May 26, 2023

SLR Project No.: 241.V20210.00001

**RE: 1 Rosetta Street, Georgetown
Review Comment Response for Proposed Development (CN and Metrolinx)**

Figure No.

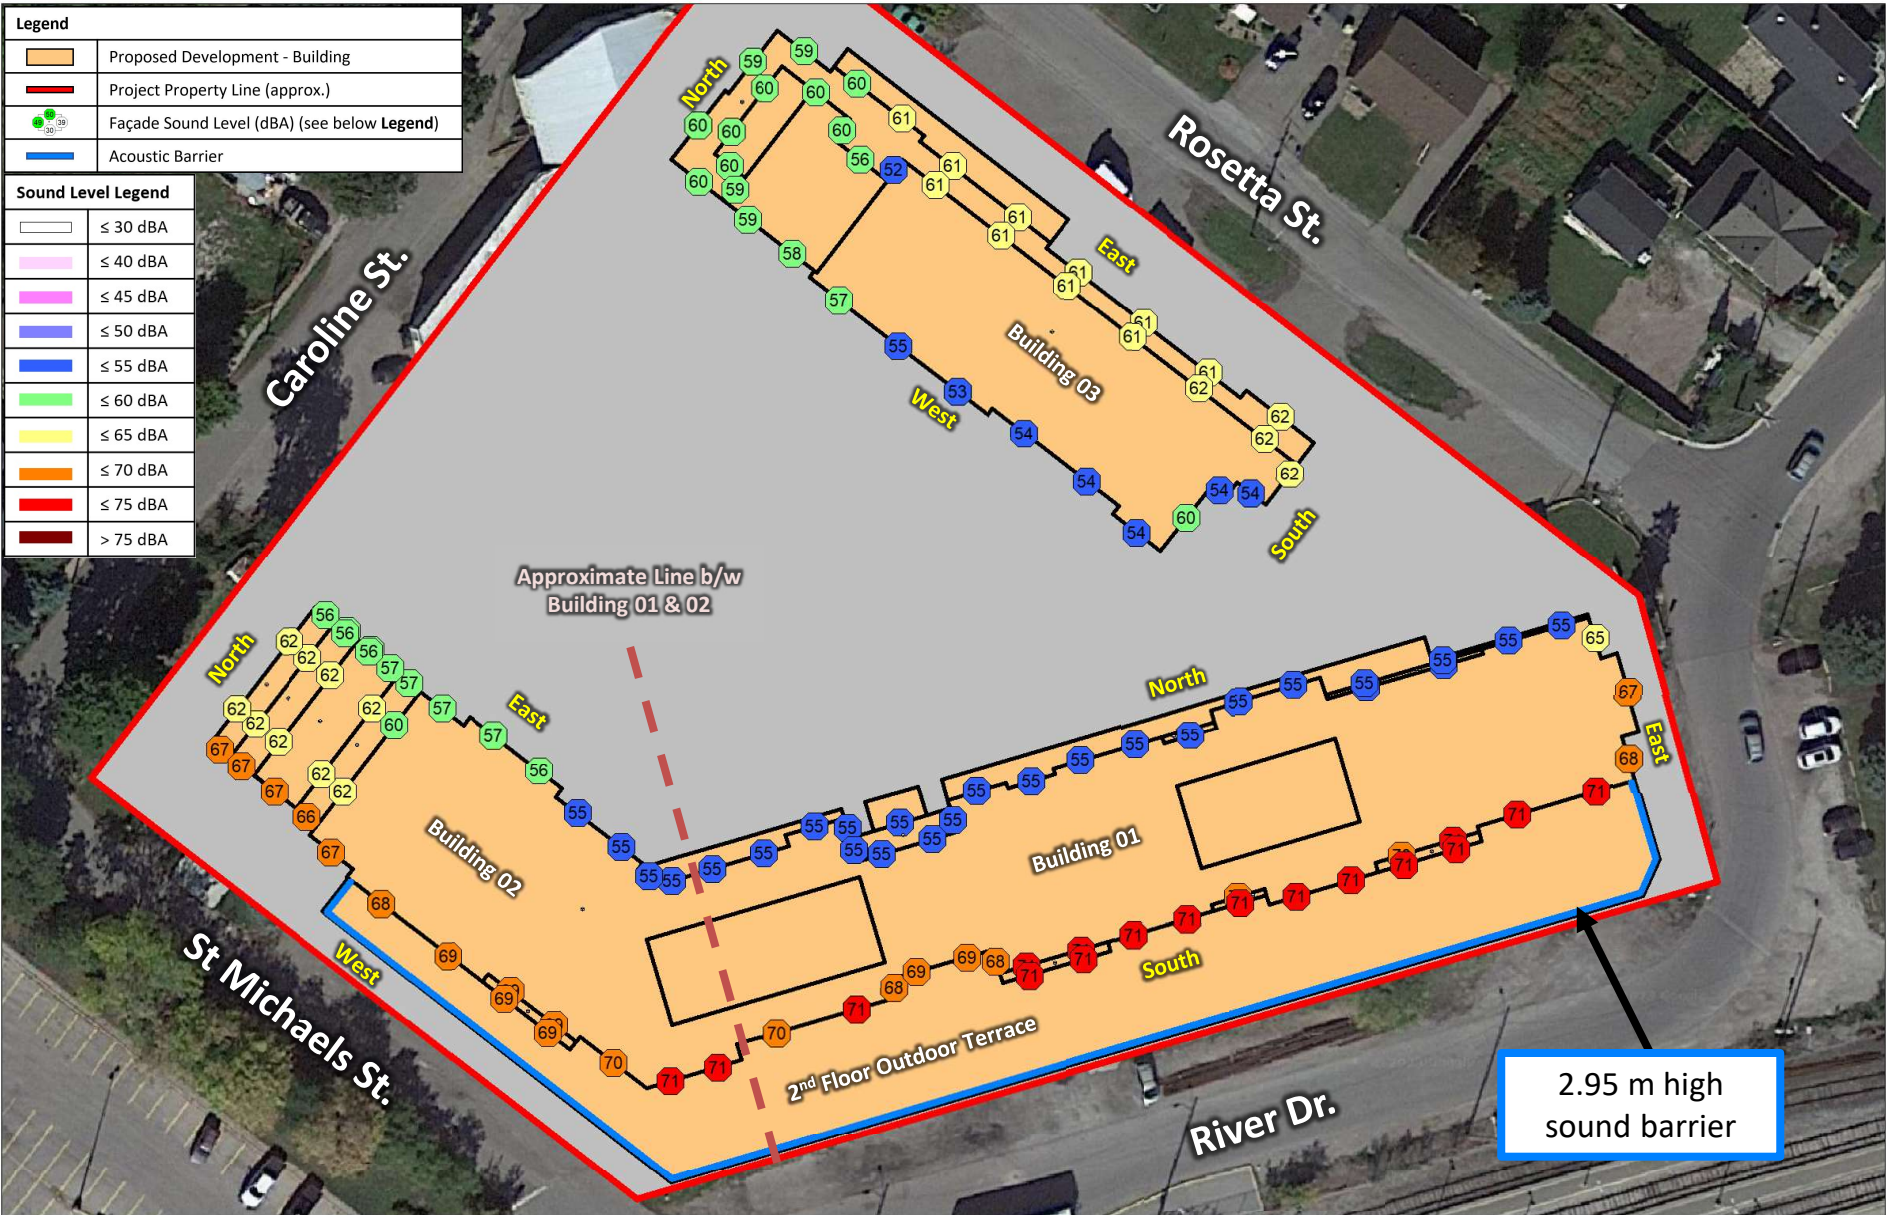
It is acknowledged that the common outdoor amenity areas have been assessed and that a 2.95 m high barrier is being proposed as part of the building design. For Table 9 and general

completeness, a footnote should be added to indicate the predicted sound level includes the 2.95 m high barrier (in terms of the applicable receptors).

A footnote has been added to **Table 9** in the Updated Environmental Noise and Vibration Study dated May 26, 2023 (**Attachment B**), confirming the predicted OLA sound level includes screening effects from the 2.95 m high barrier. This was already (and continues to be) noted in a dedicated report subsection, **Section 2.4.1**.

Figure No.

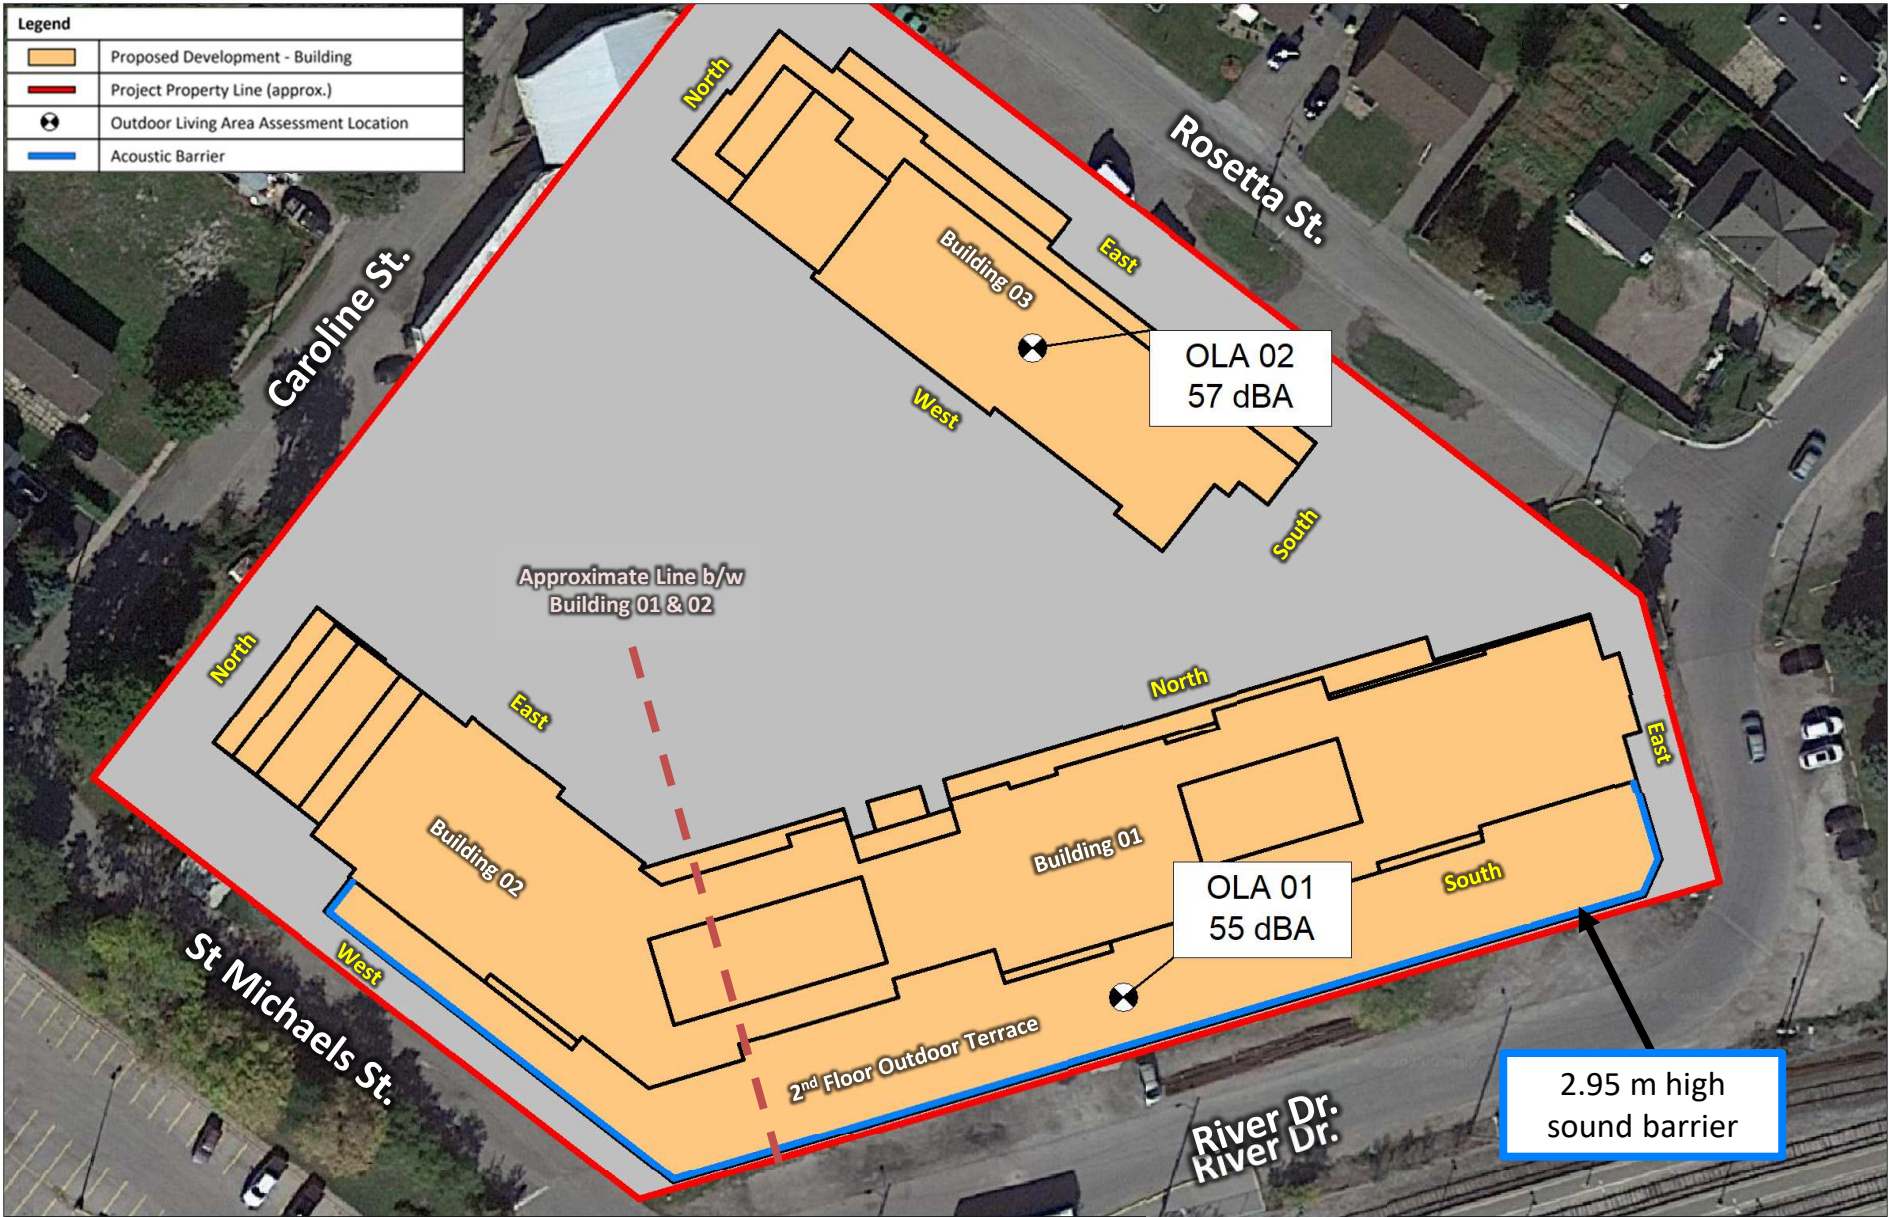
Figure 6 in the report shows the vibration monitor location. Further to the points above, it is unclear if this location was inside a building or beside a building. The distance from the railway right-of-way to the vibration location should be included on the Figure, along with clarification as to the specific vibration monitoring setup.

4. Figure 6 in the report shows the vibration monitor location. Further to the points above, it is unclear if this location was inside at building or beside a building. The distance from the railway right-of-way to the vibration location should be included on the Figure, along with clarification as to the specific vibration monitoring setup.

Figure 6 in Updated Environmental Noise and Vibration Study dated May 26, 2023 (**Attachment B**) illustrates the new measurement locations outside the building (not inside), and the distance to the key rail vibration sources.
